**BALBOA PARK PLAZA DE PANAMA
PROJECT NO. 233958/SCH NO. 2011031074
RESPONSE TO THE DEIR REGARDING THE
GOLD GULCH CANYON PARKING STRUCTURE ALTERNATIVE**

RE: Comments:
Project Name: BALBOA PARK PLAZA DE PANAMA
Project No. 233958/SCH No. 2011031074
Community Plan Area: Balboa Park
Council District: 2 (Faulconer) 3 (Gloria)

EXHIBIT 1 - GOLD GULCH ALTERNATIVE GRADING PLAN

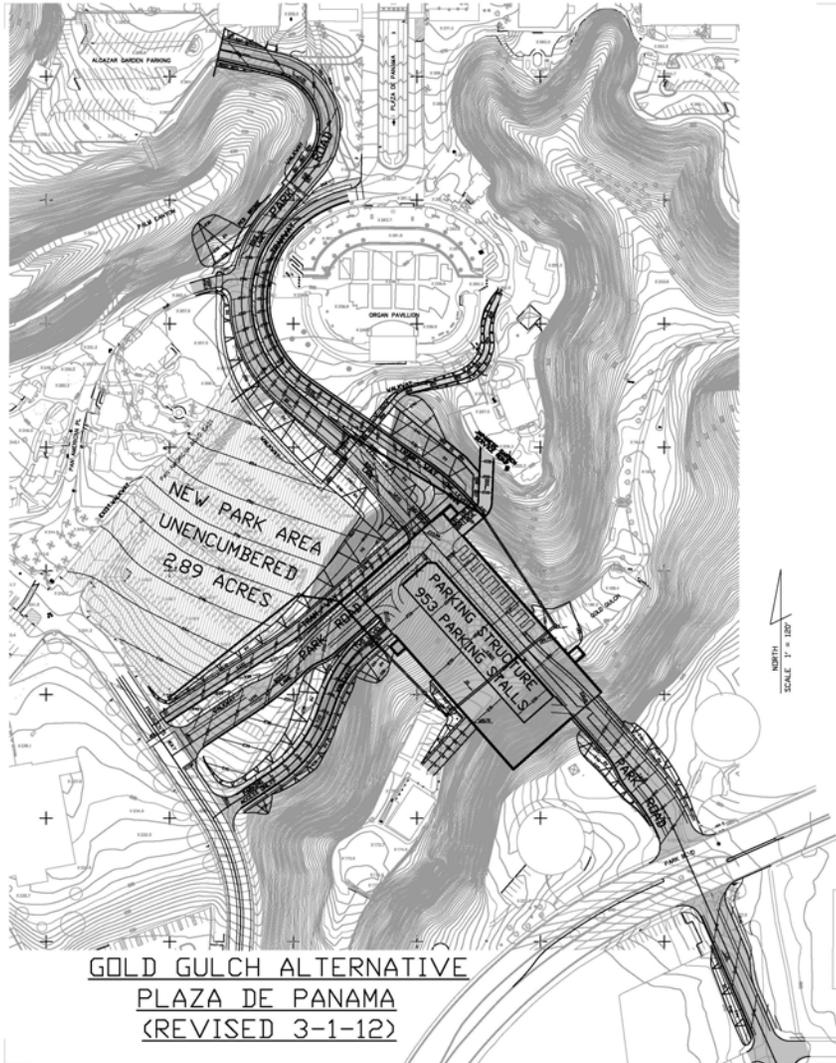
AG-2 The Gold Gulch Parking Structure Alternative has been engineered extensively with the concept being refined ever since it was first introduced to the Plaza de Panama design team in October of 2010. Attached is a detailed grading plan, aerial photo with the project overlaid, the parking structure plan view and elevations, and an aerial photo overlaid with both the Proposed Project and the Gold Gulch Alternative so the public can better understand the concept (see Exhibits 1 thru 5). It is unfortunate that this illustrative information, which was available to the DEIR preparers, was not included in the DEIR so the public would fully understand the concept.

AG-2 Comment noted. The Gold Gulch Parking Structure Alternative provided herein, although similar, is not identical to the EIR Alternative 4Ai Gold Gulch Parking Structure Alternative (see Section 9.3.4Ai.1).

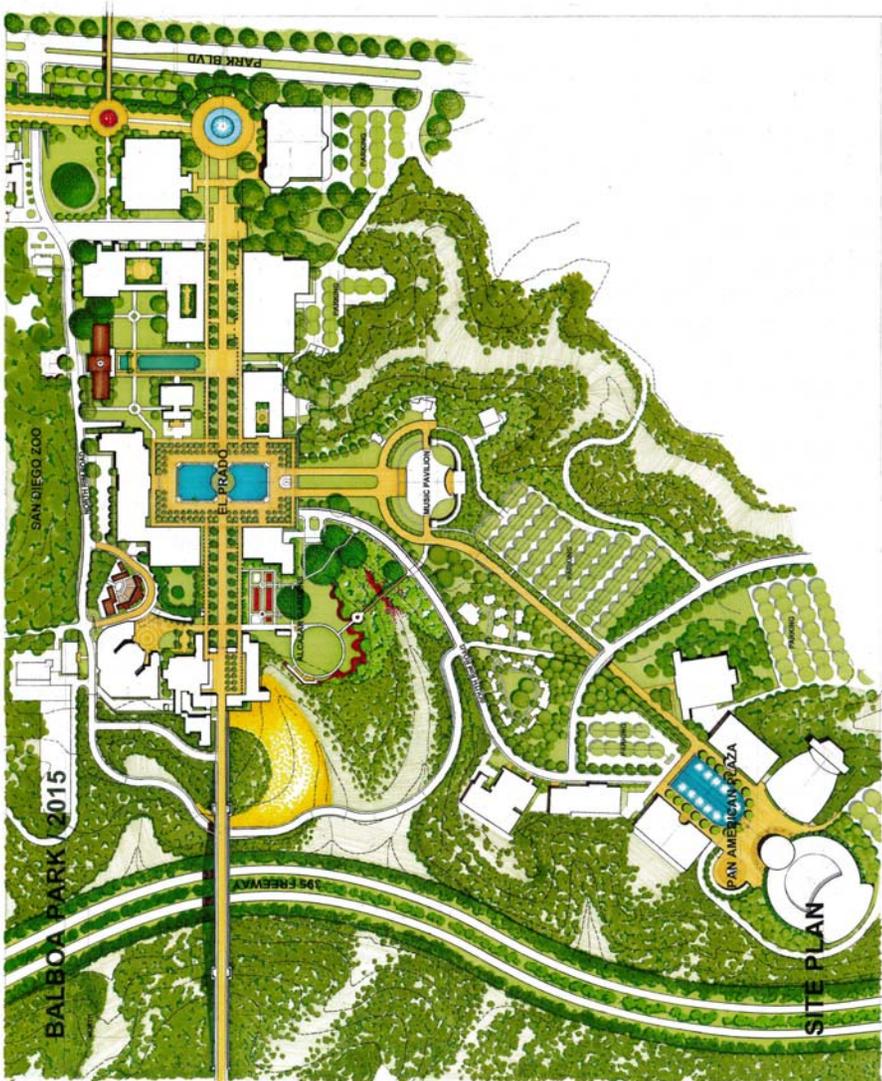
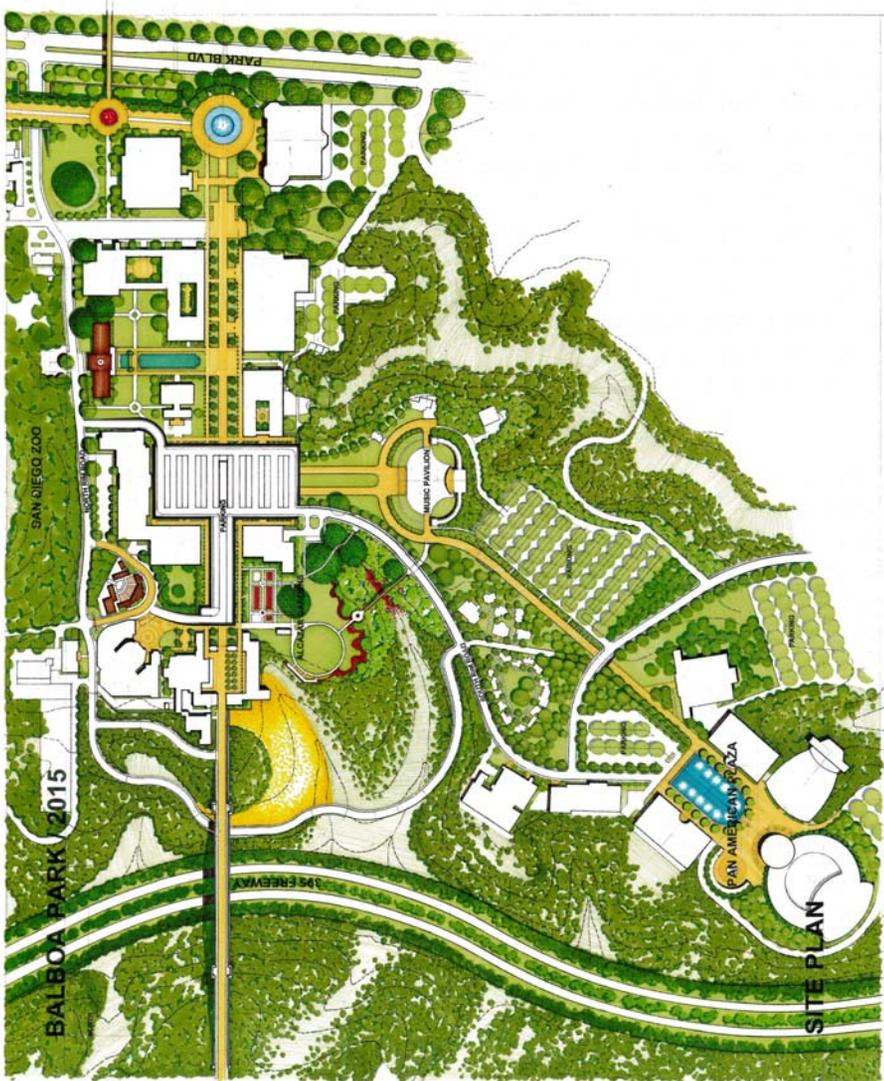
Based on review of the attached plans, the suggested alternative would likely result in greater impacts in each of these four areas.

Thus, significant unmitigated project impacts related to land use, historical resources, visual quality, and noise would likely be greater under this alternative.

Additionally, constraints that could affect the feasibility of this alternative include the following:

- Encroachment into Zoo leasehold
- Encroachment on Old Globe Theatre
- Road in front of the Old Globe's Festival Stage for a primary access into the new garage posing serious issues because the road functions as a cueing/intermission space.

In summary, while the suggested alternative would meet most of the basic project objectives, it would not avoid or substantially lessen any of the significant effects of the project and is potentially infeasible.
